ADDENDUM NO. 1
to the
CONTRACT DOCUMENTS
for
Barnett Ravine Storm Water Improvement Project
Village of Fox Point, Wisconsin

May 26, 2021

SHEET NUMBER:
5A

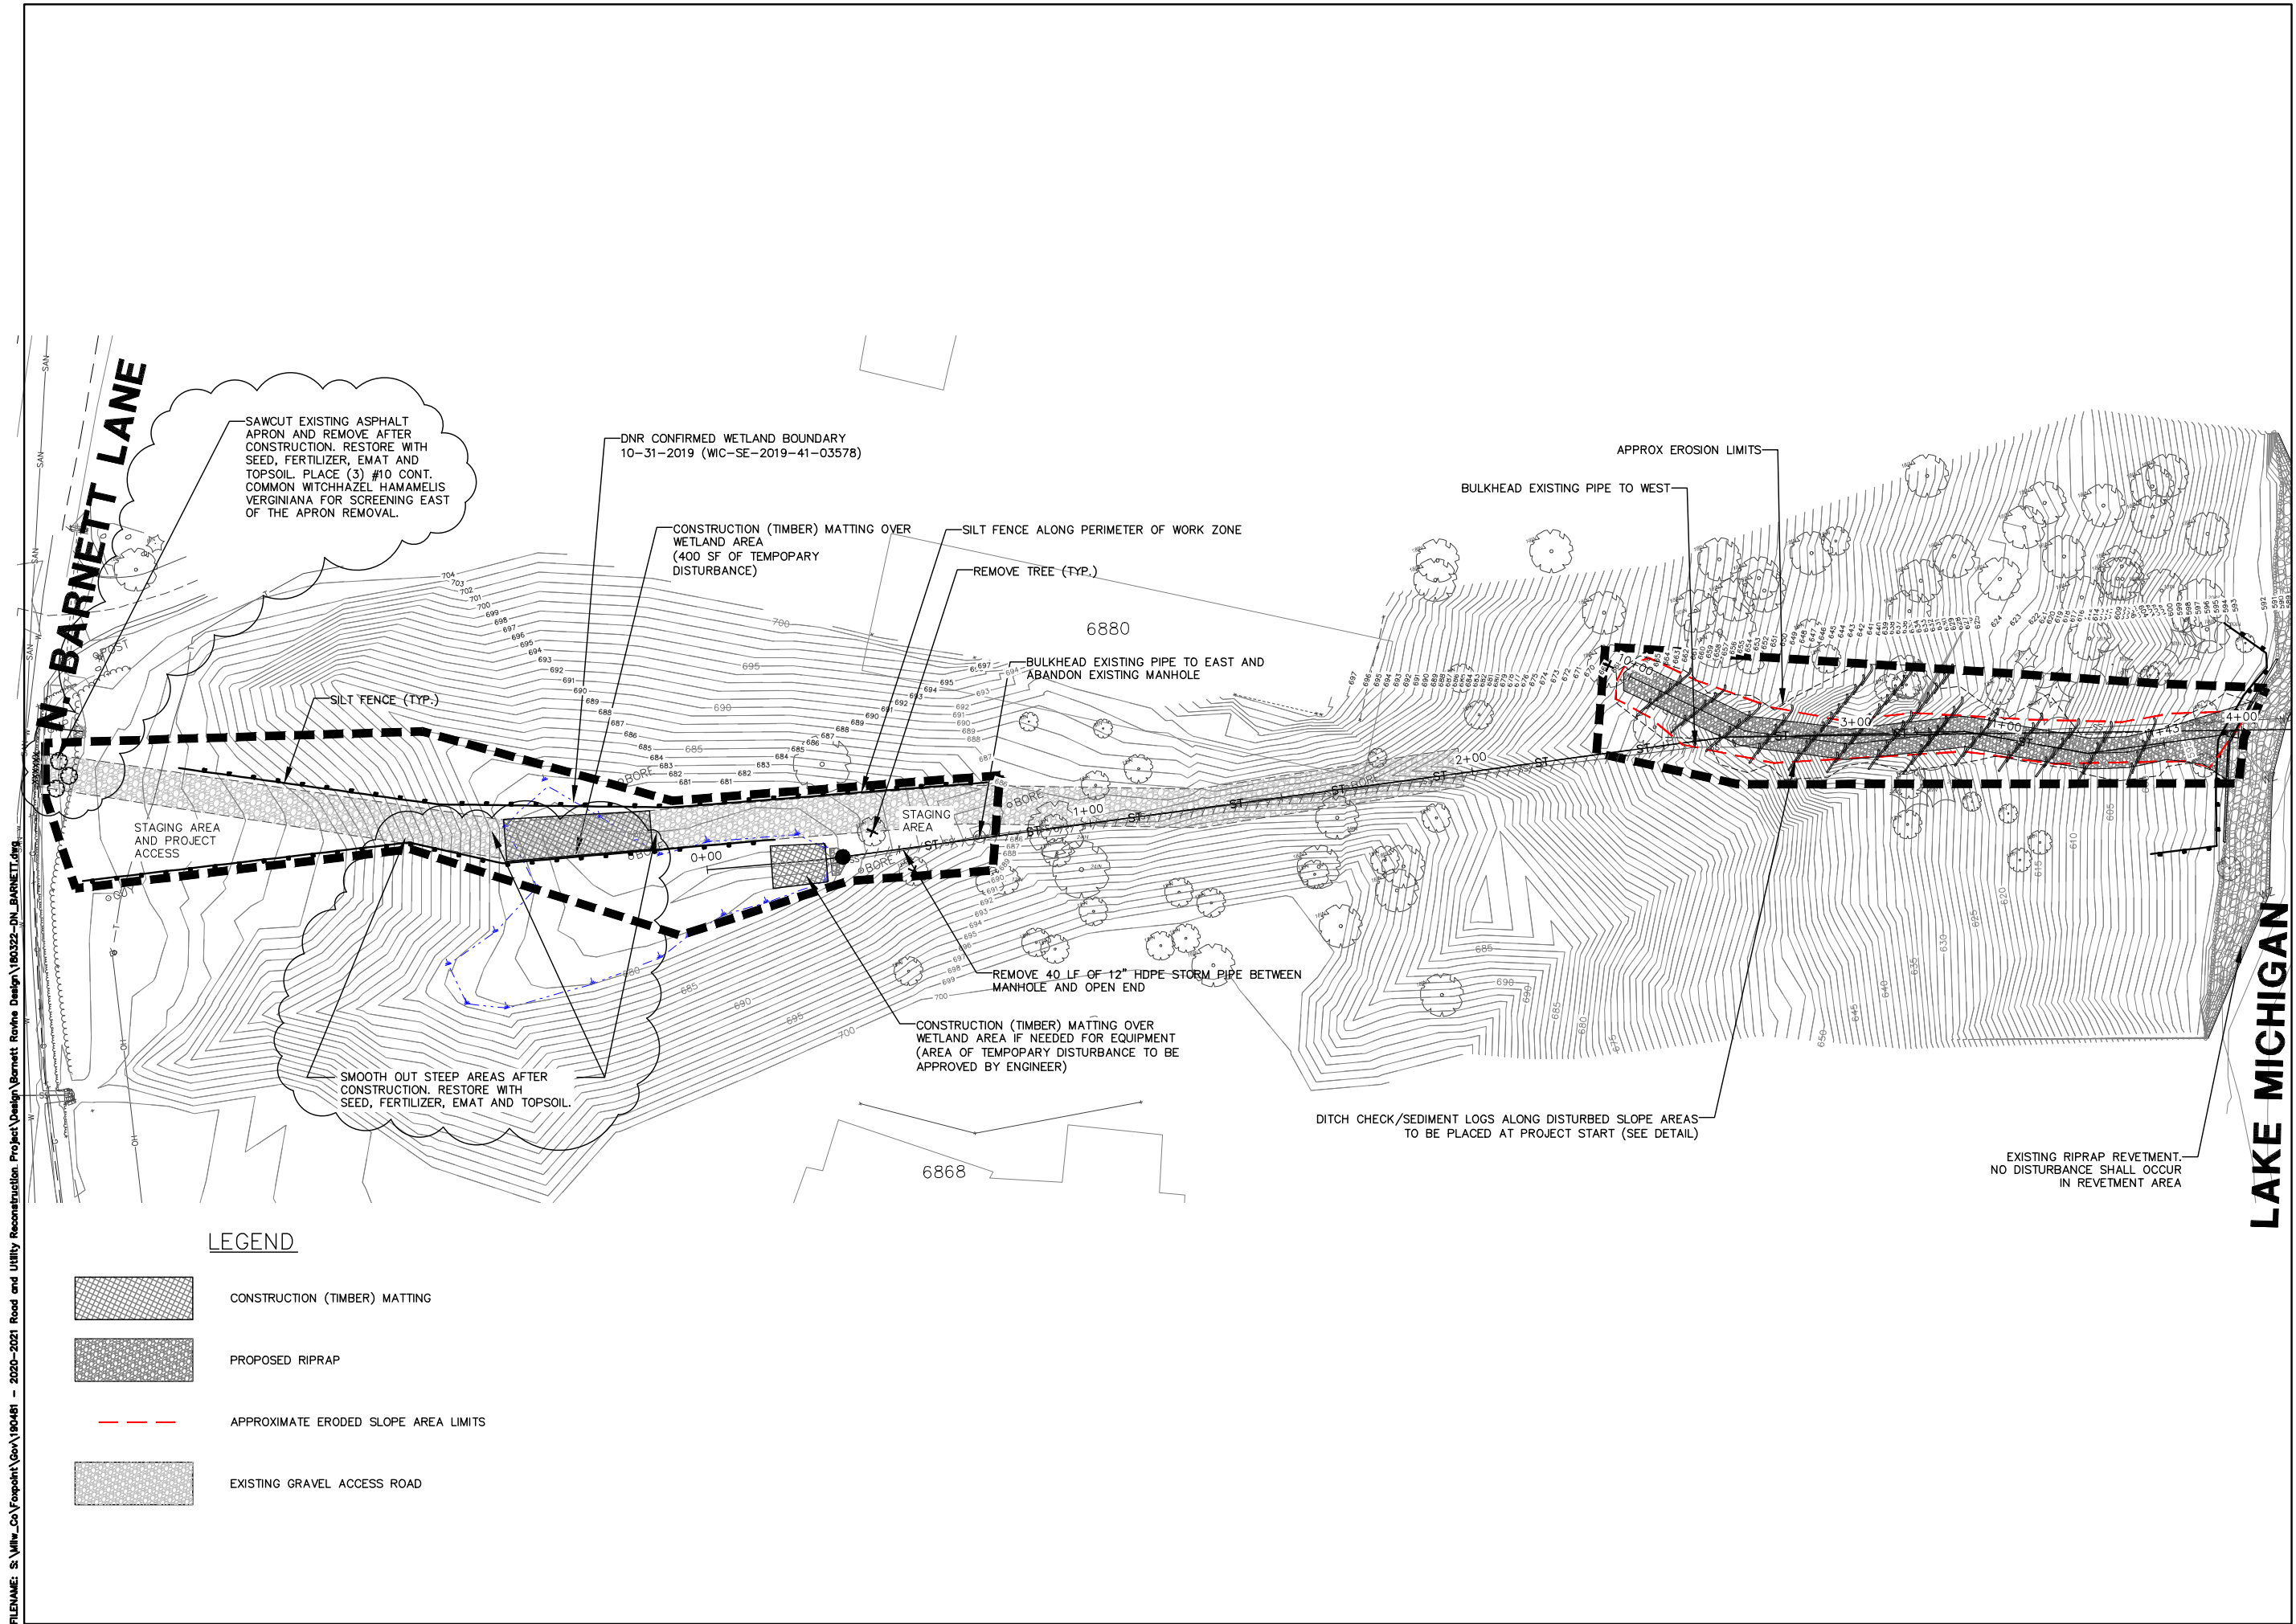
- 1. Bid opening is moved to Thursday June 3, 2021 from Tuesday June 1, 2021.**
- 2. Replace plan sheet 5 with plan sheet 5A.**
 - a. The asphalt apron along N. Barnett Lane shall be removed after construction and shall be paid for under the Excavation Common bid item. The total volume of excavation will be approximately 7 CY. Saw cutting shall incidental.**
 - b. Minor grading/restoration is required along access road to smooth out the slopes. The total volume of excavation will be approximately 3 CY. This work shall be paid for under the Excavation Common bid item.**
 - c. Common Witchhazel screening bushes shall be planted. A bid item has been added to the bid form (see below).**
- 3. Replace Bid Form Sheet BF-3 with BF-3A.**
 - a. Add bid item 23-632.0201 Shrubs (Hamamelis Virginiana, 10 gallon)**
 - b. Increase Excavation Common quantity by 10 CY to 120 CY.**
